Addendum No. 2

Delaware Army National Guard
Stern Armory/Readiness Center – Interior Renovation (Re-Bid)
Wilmington, Delaware
OMB/DFM Contract No.: MC7601000098
DEARNG Contract No.:2018-08

Addendum No. 02 (Re-Bid)
to
Drawings and Project Manual
September 3, 2018

A. SET #1

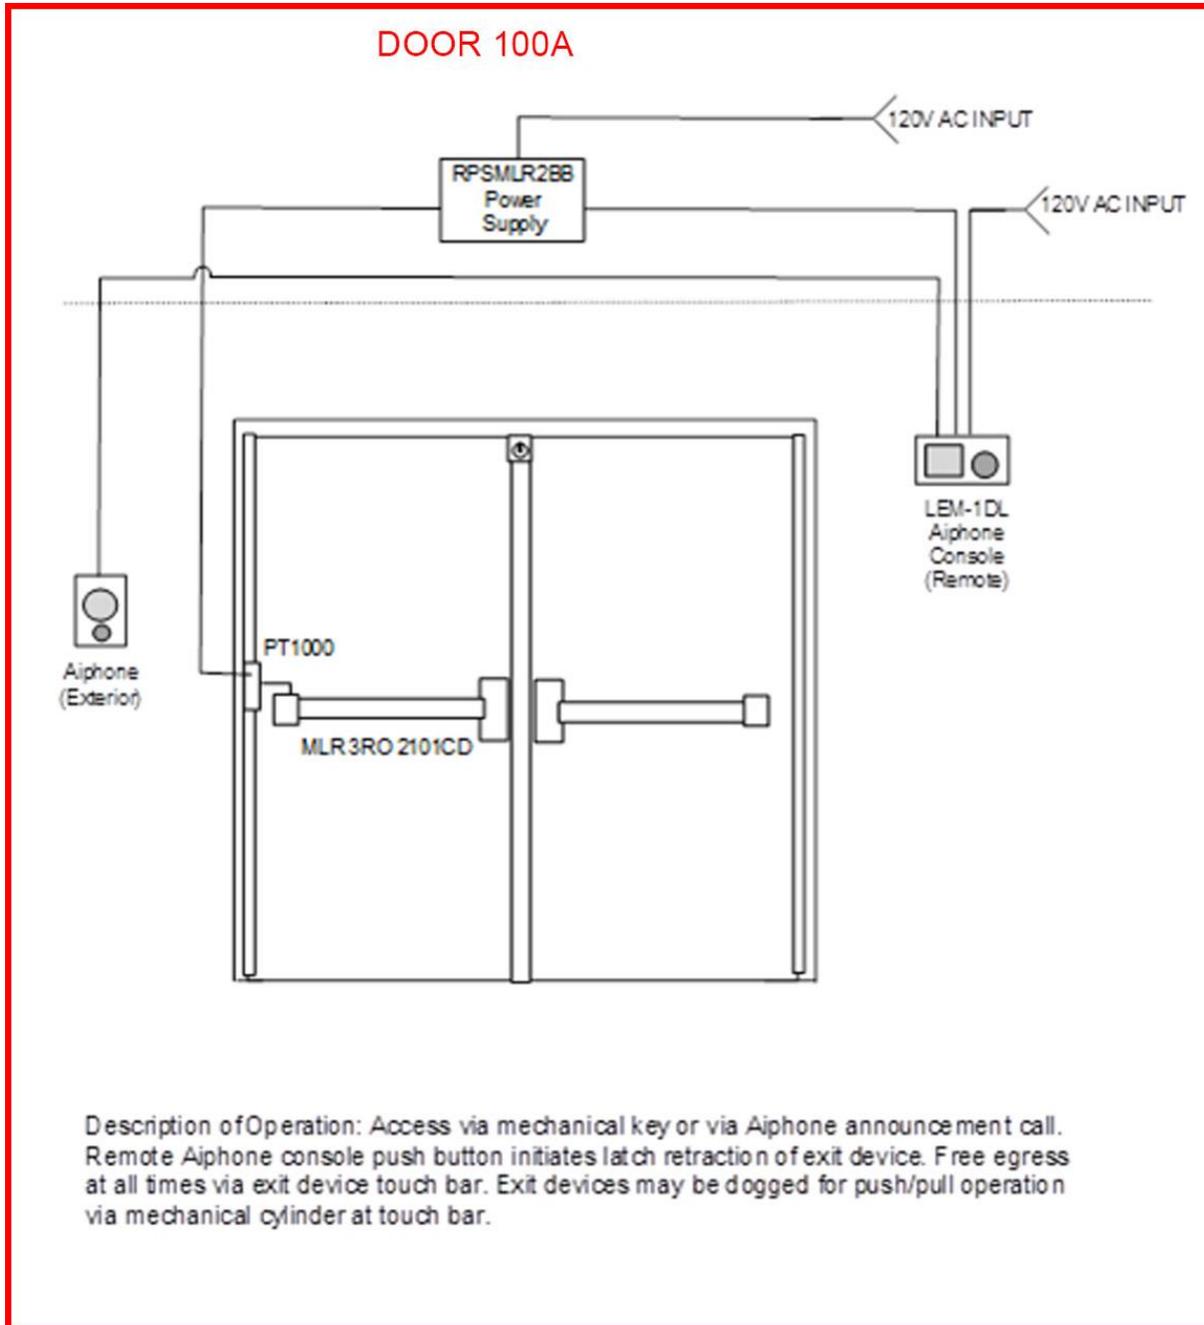
Doors: 100A

Description of Operation: Access via mechanical key or via Aiphone announcement call. Remote Aiphone console push button initiates latch retraction of exit device. Free egress at all times via exit device touch bar. Exit devices may be dogged for push/pull operation via mechanical cylinder at touch bar.

WALL INFILL SILL DETAIL AT GYM ROOM 107A

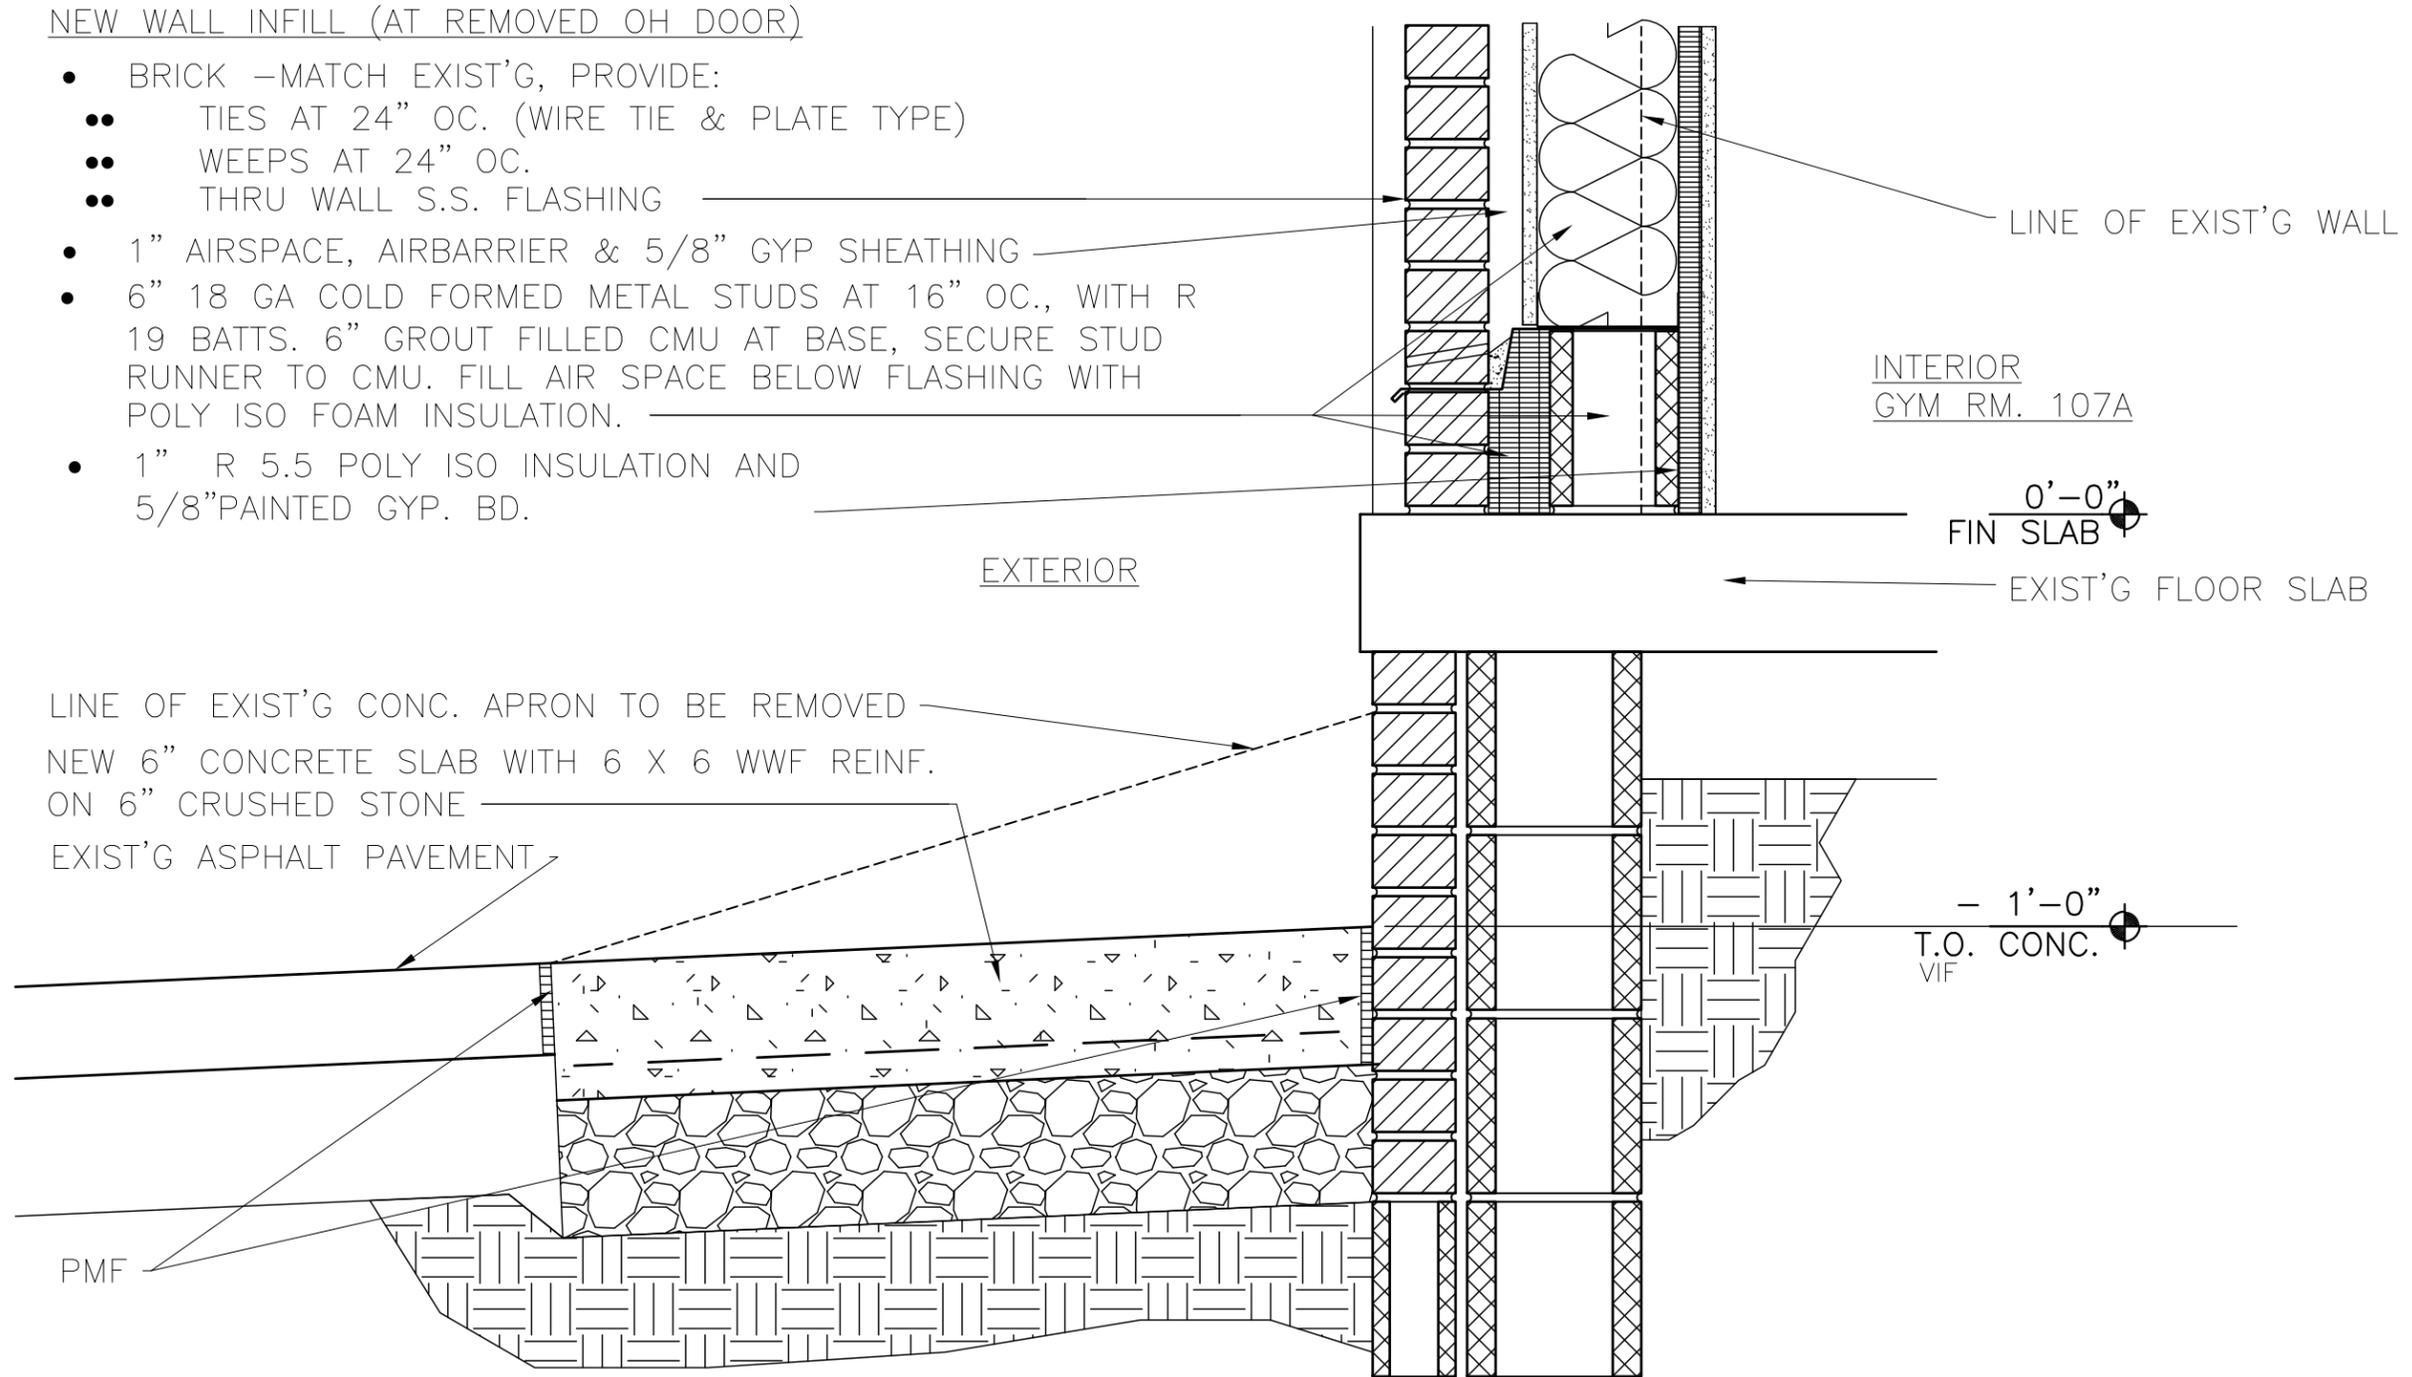
- BRICK -MATCH EXIST'G, PROVIDE:
 - TIES AT 24" OC. (WIRE TIE & PLATE TYPE)
 - WEEPS AT 24" OC.
 - THRU WALL S.S. FLASHING
- 1" AIRSPACE, AIRBARRIER & 5/8" GYP SHEATHING
- 6" 18 GA COLD FORMED METAL STUDS AT 16" OC., WITH R 19 BATTS. 6" GROUT FILLED CMU AT BASE, SECURE STUD RUNNER TO CMU. FILL AIR SPACE BELOW FLASHING WITH POLY ISO FOAM INSULATION.
- 1" R 5.5 POLY ISO INSULATION AND 5/8" PAINTED GYP. BD.

LINE OF EXIST'G CONC. APRON TO BE REMOVED
 NEW 6" CONCRETE SLAB WITH 6 X 6 WWF REINF.
 ON 6" CRUSHED STONE
 EXIST'G ASPHALT PAVEMENT

THIS SKETCH MODIFIES DRAWING A-601
